**From:** noreply@feedback.planningportal.nsw.gov.au  
**Sent:** Monday, 28 February 2022 4:17 PM  
**To:** PDPS DRDE Design and Place SEPP Mailbox  
**Cc:** DPE PS ePlanning Exhibitions Mailbox  
**Subject:** Webform submission from: The Design and Place SEPP 2021  
**Attachments:** letter-to-dpe---draft-dp-sepp---28-february-2022.pdf

**Contact:** D Christy  
**Reference:** DOC22/22935

**Department of Planning and Environment**  
**SUBMITTED VIA PLANNING PORTAL**

Figure 1: 800m Radius from Auburn Street & Heritage Conservation Area

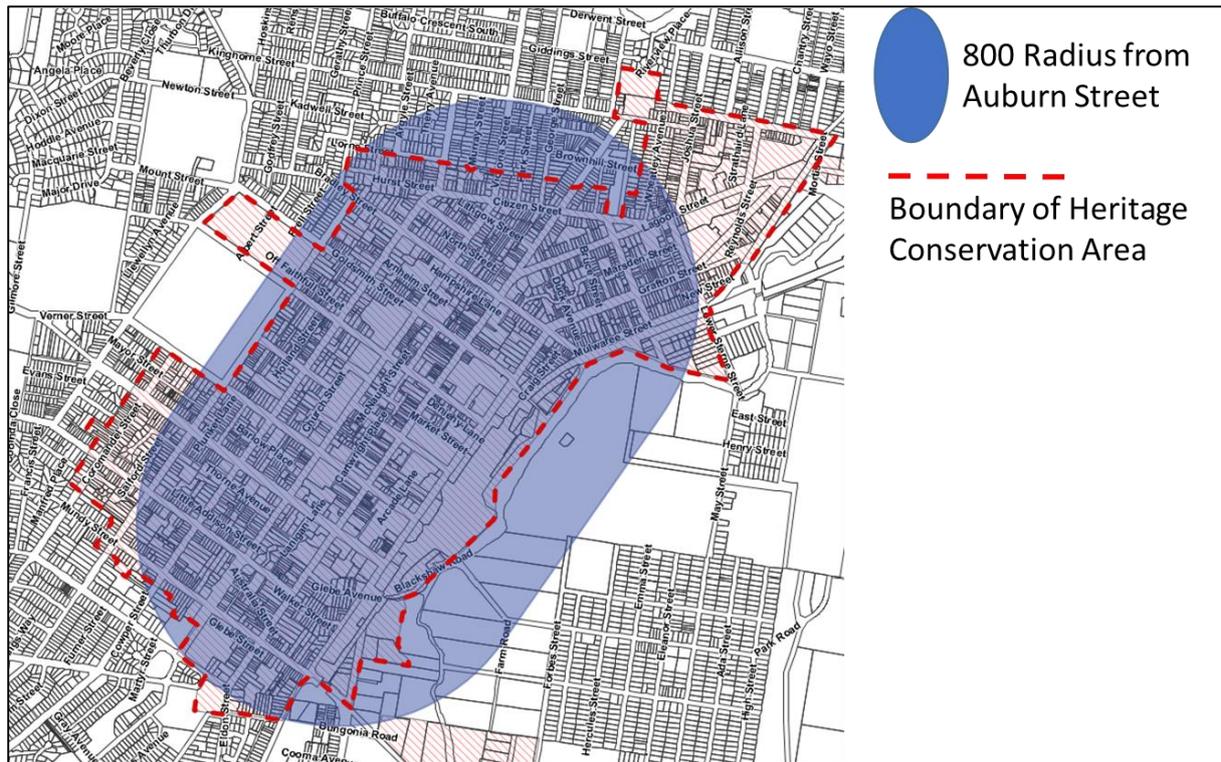
The density requirement of 30dph within a 10 minute walk (800m) of regional centres also raises concerns regarding the achievability and potential impacts such a requirement may have on the historic character of Goulburn. **Figure 1** illustrates an 800m radius from the Goulburn CBD which is the focus of retail and service provision and the extent of the heritage conservation area. As **Figure 1** illustrates most of the 800m radii encompasses the heritage conservation area where average density currently stands at approximately 10dph. An expected threefold increase in density within the heritage conservation area would change the low density character which defines the streetscape and place undue pressure on the demolition of heritage items and/or over development of heritage lots to the overall detriment of Goulburn's historic character.

Figure 3: Inadequate waste storage due to bin bay not being built to requirements (overflow waste).

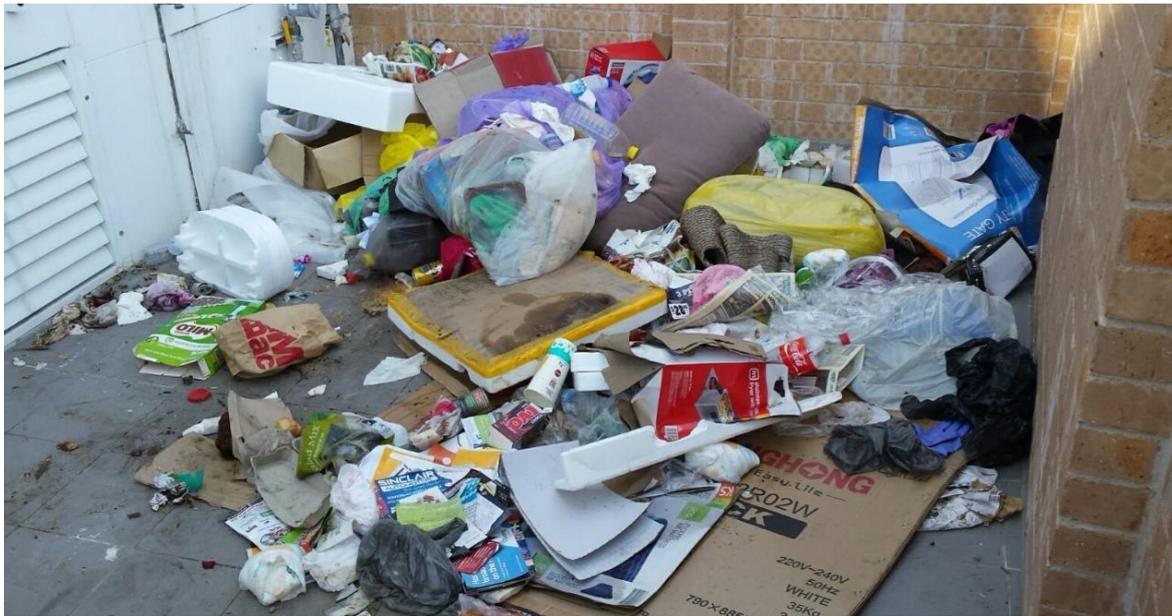
Failing to adequately design and construct waste storage and collection facilities in apartment buildings can have significant impact on amenity, safety of the building footprint and the neighbouring vicinity and streetscape. While design experts generally understand the ramifications of failing to address the needs of other essential service requirements such as fire safety, electricity, water and sewage, the outcomes of poor waste management servicing on safety and amenity are far less understood. The following images demonstrate the reality of poor design outcomes.
